Current Zoning: R-3 (single family residential)  
 Proposed Zoning: UR-2(CD) (urban residential, conditional) with five-year vested rights.

Approximately 3.49 acres located on the east side of Park Road, north of Sharon Road.  
 (Council District 6 - Bokhari)

The petition proposes redevelopment of four parcels containing three single family homes with a 20-unit, single family attached development along Park Road north of Sharon Road.

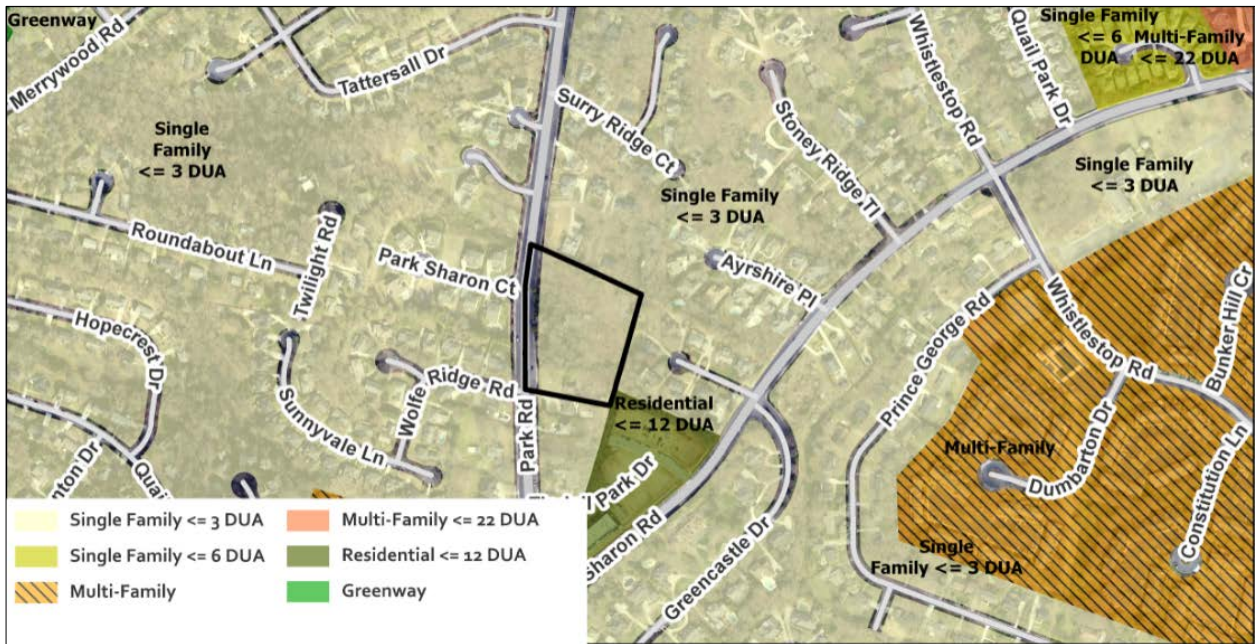
1. Remove the section of internal sidewalk, shown below, that is parallel to the northern most driveway between the proposed sidewalk along Park Road and the existing back of curb sidewalk because the existing back of curb sidewalk should be removed.
